River Bend Station Unit 1
Docket No. 50-458

Enclosed for your review are Gulf States Utilities Company's supplemented responses to items identified by the Nuclear Regulatory Commission's Structural and Geotechnical Engineering Branch (SGEB). Enclosure 1 provides the response which will be included in a future amendment to the FSAR.

2.5.4.13.2.2 Category I Structure Settlement Monitoring Results

For FSAR Page 2.5-129

FIGURE 2.5-103

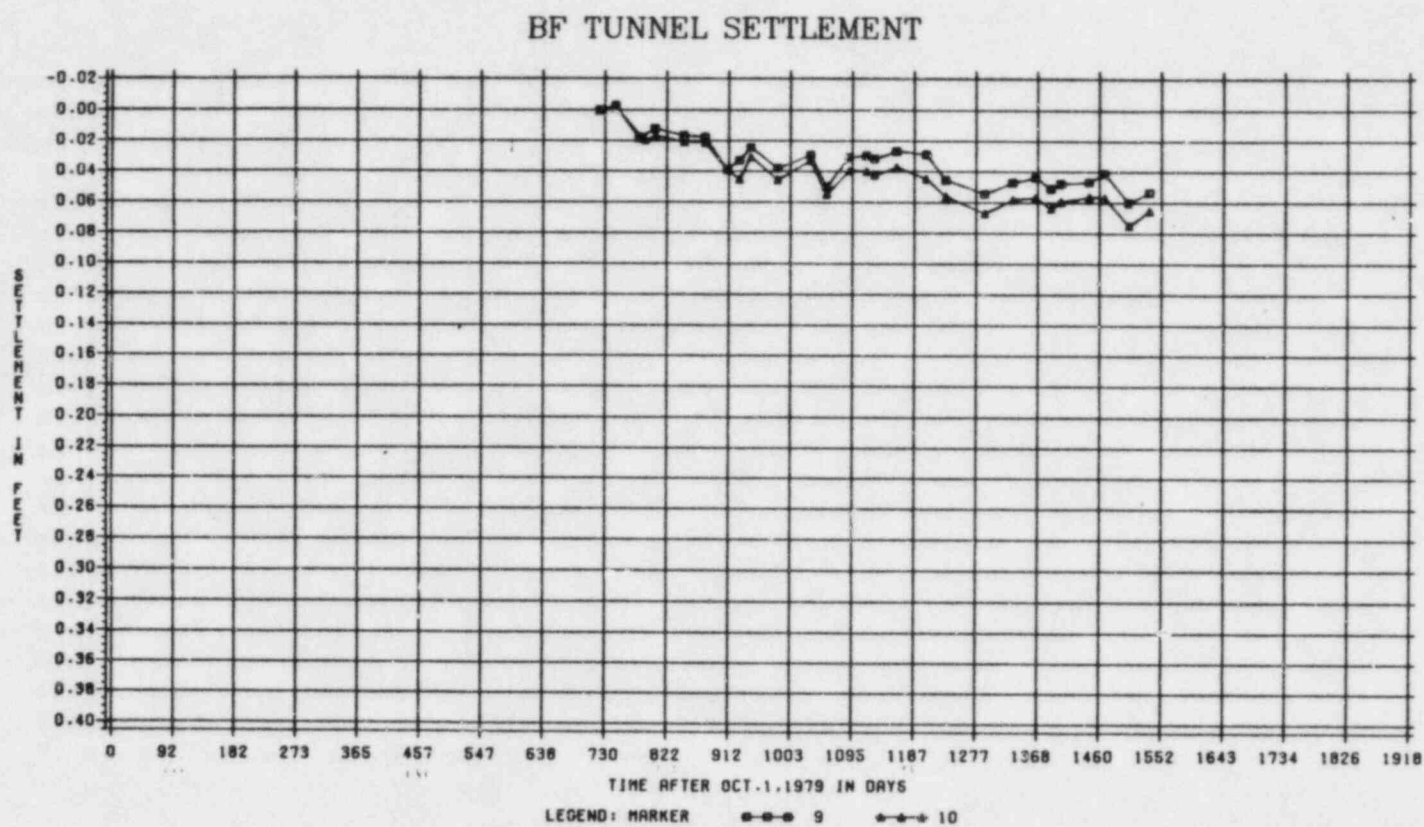
This may be demonstrated by examining the settlement records for BF Tunnel (Figure 2.5-103). BF Tunnel exerts a bearing pressure of approximately 2.3 ksf at an average elevation of 65 ft msl. The load that would be exerted by an equivalent volume of backfill is approximately 3.6 ksf. As shown in Table 2.5-17 bearing pressures for the Fuel, Diesel Generator, and Reactor Buildings vary from 6 to 8 ksf.

Figure 2.5-103 shows that settlement of the BF tunnel (Markers 9 & 10) has been essentially uniform. The differential settlement over the length of the tunnel is 0.12 in. In the period between September 1981 and December 1983, markers 9 and 10 settled approximately 0.66 in. and 0.78 in., respectively. In the same period of time, the west side of the Diesel Generator Building, markers 3 and 4 (Figure 2.5-98) settled 0.48 and 0.84 in., respectively, and marker 12 on the east side of the Fuel Building (Figure 2.5-1-1) settled 0.90 in. The differential settlement between the east end of BF Tunnel and the Diesel Generator Building may be computed as the difference between the average settlements of markers 3 and 4 and the settlement at marker 9, or $(0.48 + 0.84)/2 - 0.66 = 0$ in. Between the west end of BR Tunnel and the Fuel Building, differential settlement is $0.90 - 0.78 = 0.12$ in.

FIGURE 2.5-106a

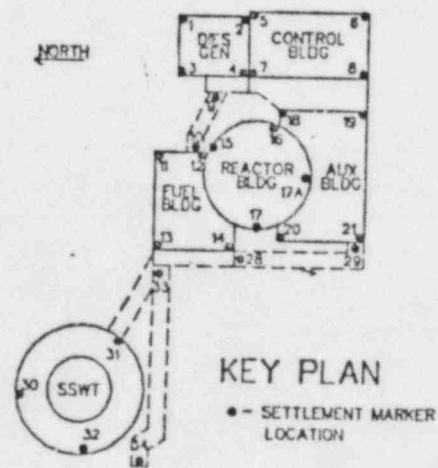
Figure 2.5-106a shows the location of settlement markers in the Unit 1 area.
